P&Z CASE # 82019-088 P&Z DATE 8/13/2019 CC DATE \_\_\_\_\_ APPROVED/DENIED \_\_\_\_\_  
ARCHITECTURAL REVIEW BOARD DATE \_\_\_\_\_ HPAB DATE \_\_\_\_\_ PARK BOARD DATE \_\_\_\_\_

PLANNING & ZONING CASE NO. SP2019-020

**Project Number: SP2019-028**  
**Project Name: Northgate**  
**Project Type: SITE PLAN**  
**Applicant Name: MICHAEL JOYCE PROPERTIES**  
**Owner Name: ROBERSON, COREY WAYNE**  
**Project Description:**

**TO:** Planning and Zoning Commission  
**DATE:** August 13, 2019  
**APPLICANT:** Ryan Joyce; Michael Joyce Properties  
**CASE NUMBER:** SP2019-028; *Site Plan for Northgate Subdivision*

PRELIMINARY SITE PLAN  
NORTHGATE  
CITY OF ROCKWALL  
DALLAS COUNTY, TEXAS

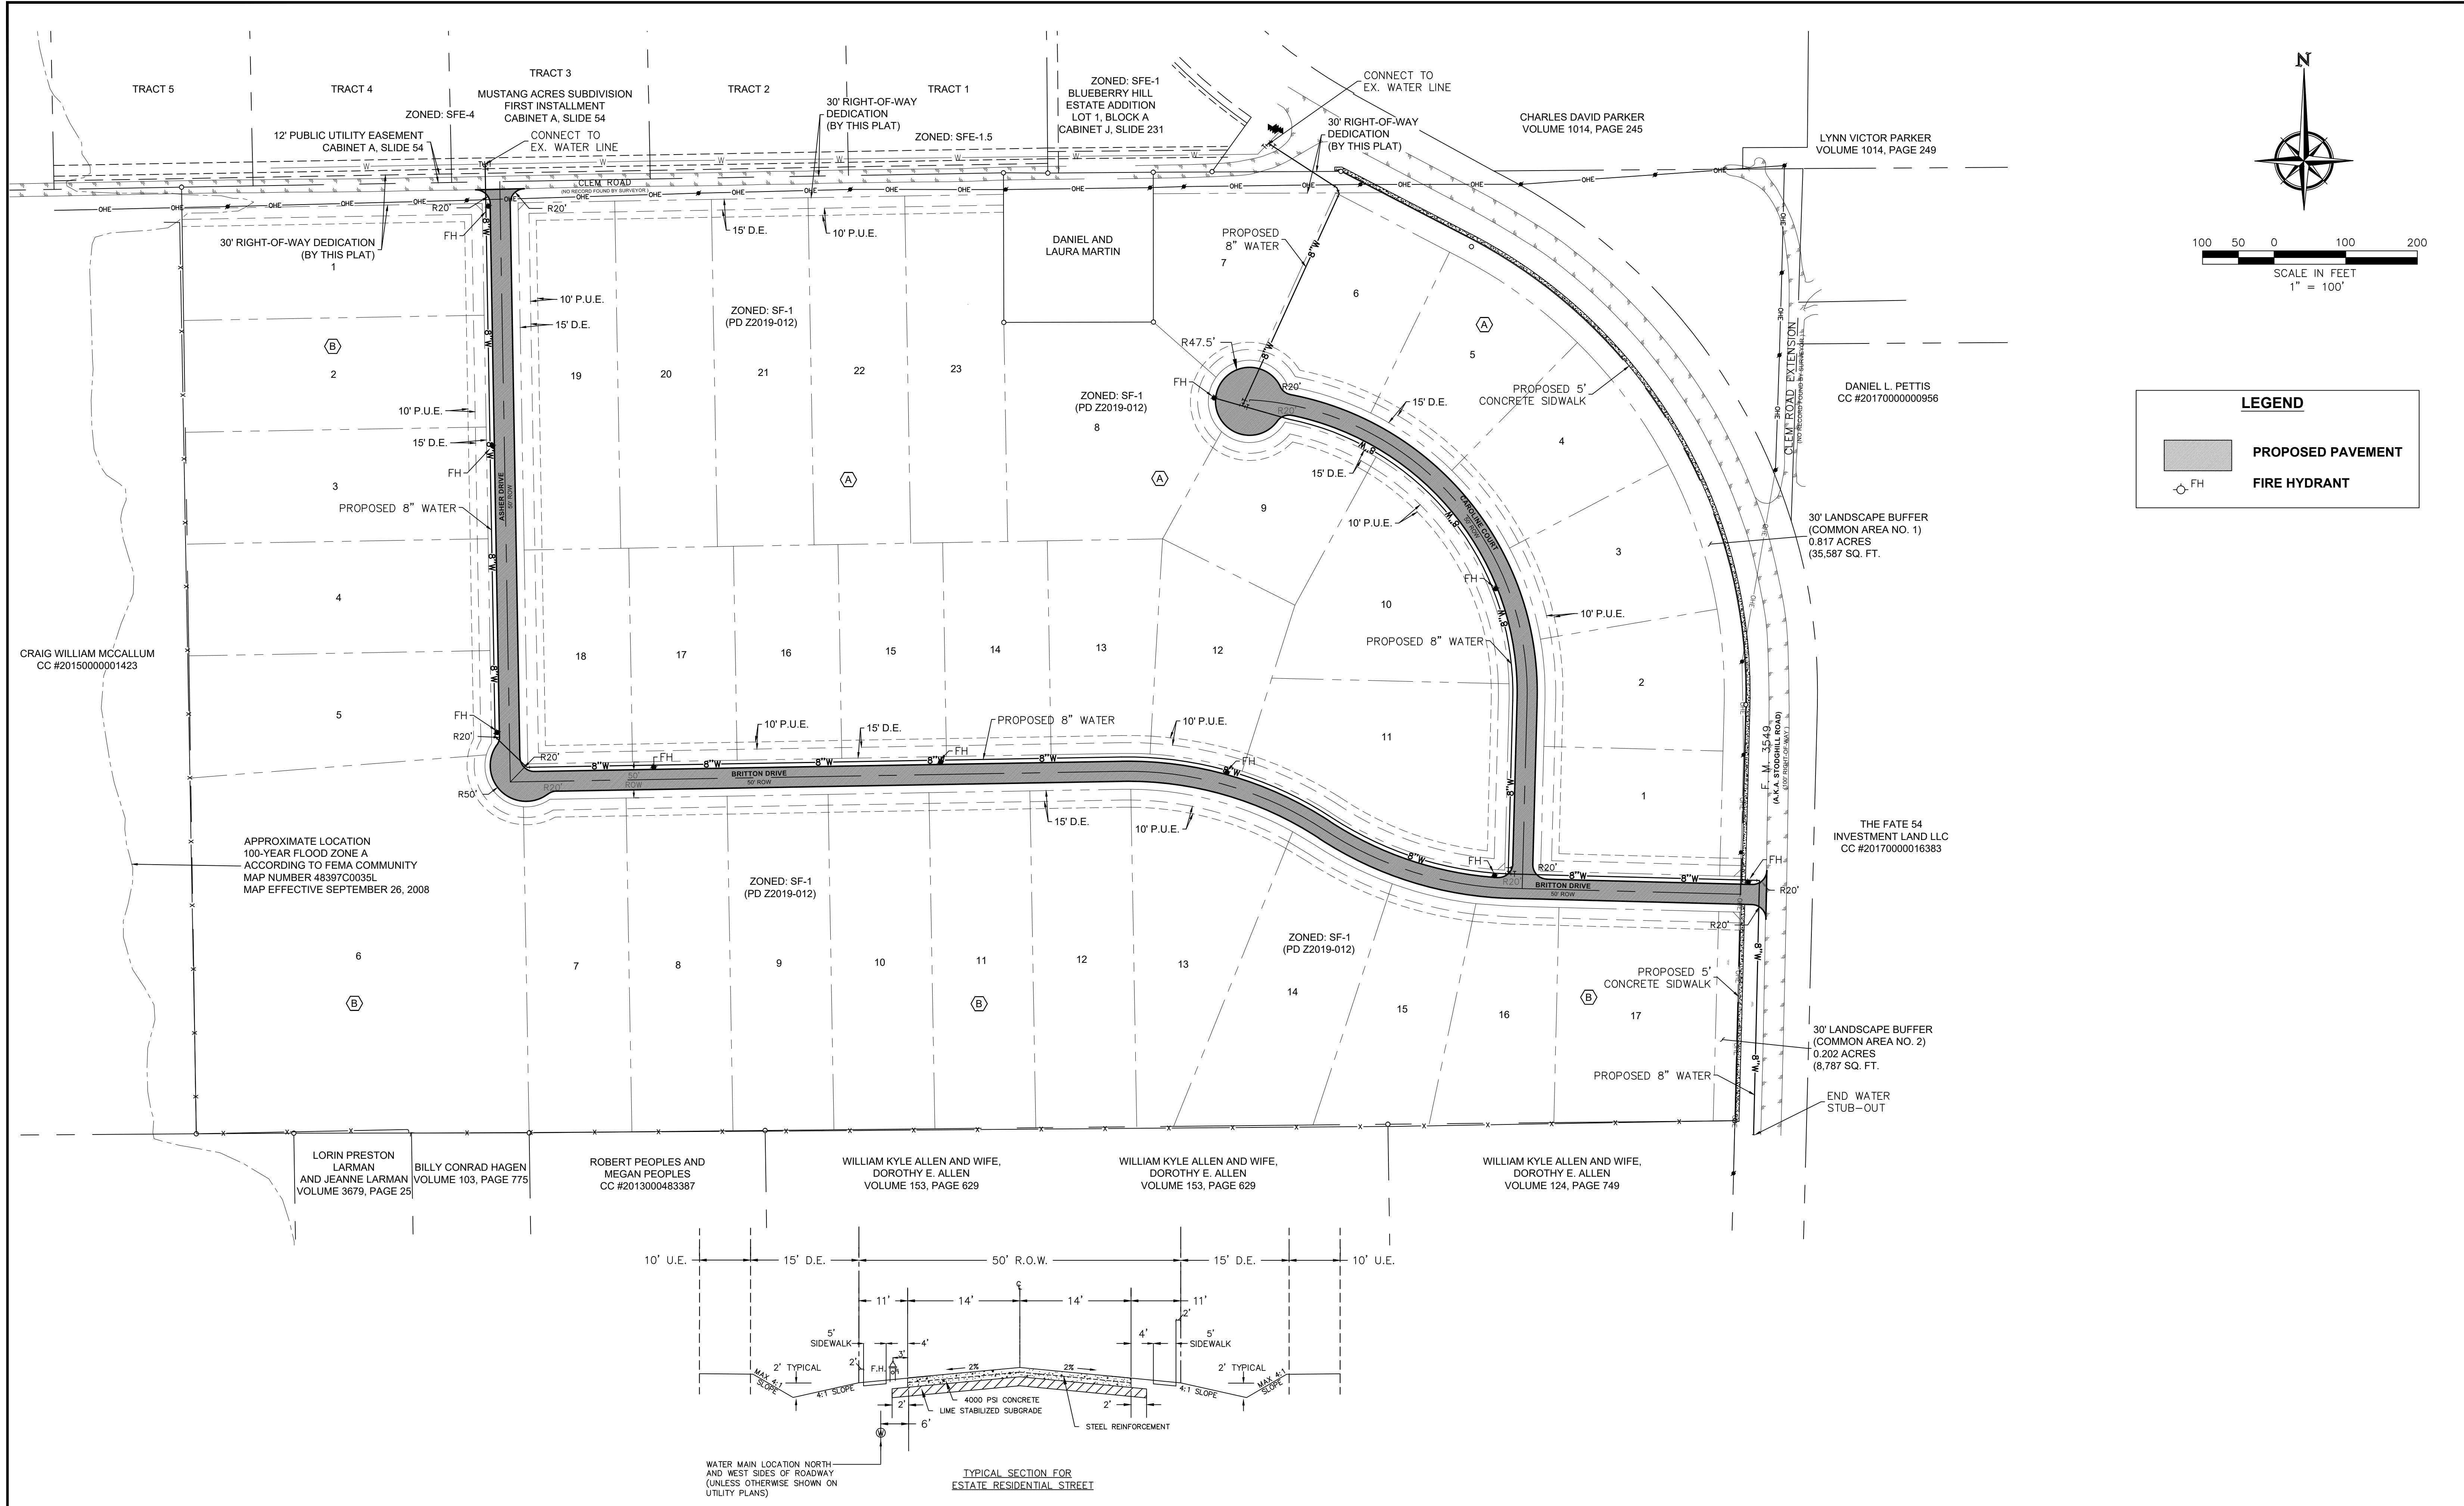
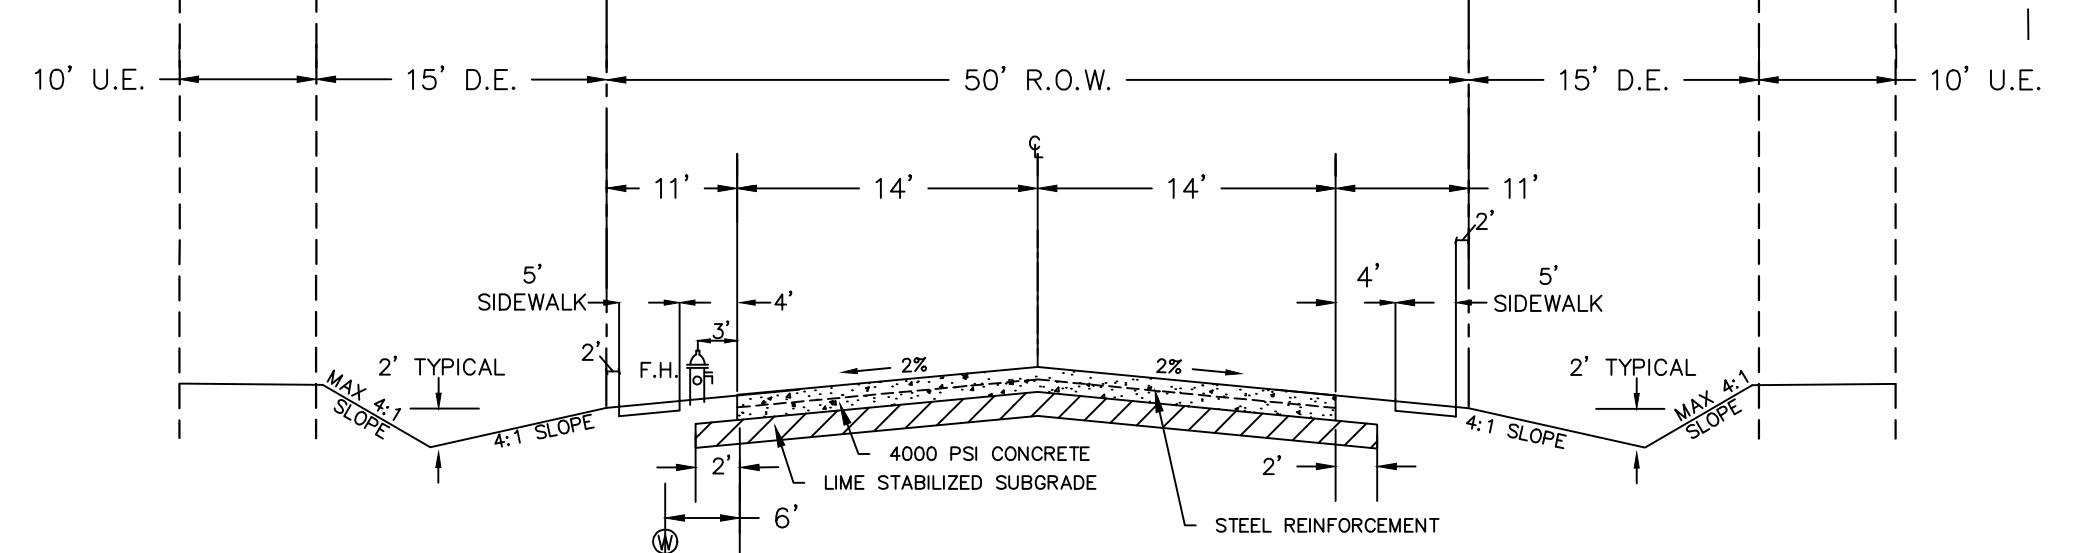
I.2						For questions or comments concerning this case, please contact Korey Brooks in the Planning Department at (972) 772-6434 or email kbrooks@rockwall.com.
M.3						For reference, include the case number (SP2019-028) in the lower right hand corner of all pages on future submittals.
M.4						Please note, Landscaping shall be reviewed and approved with the PD Site Plan. All Canopy/Shade Trees planted within this development shall be a minimum of four (4) caliper inches in size and all Accent/Ornamental/Under-Story Trees shall be a minimum of four (4) feet in total height.

(1)						Landscape Buffers. All landscape buffers and plantings located within the buffers shall be maintained by the Homeowner's Association (HOA).
(c)						Landscape Buffer and Sidewalks (FM-3549). A minimum of a 30-foot landscape buffer shall be provided along FM-3549 (outside of and beyond any required right-of-way dedication), and shall incorporate ground cover, a built-up berm and/or shrubbery or a combination thereof along the entire length of the frontage. Berms and/or shrubbery shall have a minimum height of 30-inches and a maximum height of 48-inches. In addition, three (3) canopy trees and four (4) accent trees shall be planted per 100-feet of linear frontage. The developer shall also be responsible for the construction of a five (5) foot sidewalk situated within the 30-foot landscape buffer adjacent to FM-3549.

(d)						Landscape Buffer and Sidewalks (Clem Road). A minimum 20-foot landscape buffer shall be provided
(2)						Street Trees. Prior to issuance of a Certificate of Occupancy (CO), all residential single-family lots situated within the proposed subdivision shall be landscaped with canopy trees from the list stipulated by Section 7.1 of this ordinance in the following sizes and proportions:

(i)						Three (3), three (3) inch trees measured six (6) inches above the root ball shall be planted in the front yard of the required lots
(ii)						Two (2), three (3) inch trees measured six (6) inches above the root ball shall be planted in the rear yards of the required lots.
(iii)						Two (2), three (3) inch trees measured six (6) inches above the root ball shall be planted in the side yards facing the street.

(3)						Irrigation Requirements. Irrigation shall be installed for all required landscaping located within common areas, landscape buffers and/or open space. Irrigation installed in these areas shall be designed by a Texas licensed irrigator or landscape architect and shall be maintained by the Homeowner's Association (HOA).

(4)						Hardscape. Hardscape plans indicating the location of all sidewalks and trails shall be reviewed and approved with the PD Site Plan.
a.						Streets. All streets (excluding drives, fire lanes and private parking areas) shall be built according to the City's street standards as shown below in Figure 3 of the PD ordinance.

(5)						Neighborhood Signage and Enhancements. Permanent subdivision identification signage shall be permitted at all major and minor entry points for the proposed subdivision (shown in Figure %) of the PD ordinance. Final design and location of any entry features shall be reviewed and approved with the PD Site Plan. The developer shall provide enhanced landscaping areas within the Subject Property as generally depicted in Figure 4 of the PD Ordinance. The final design of these areas shall be provided on the PD Site Plan.
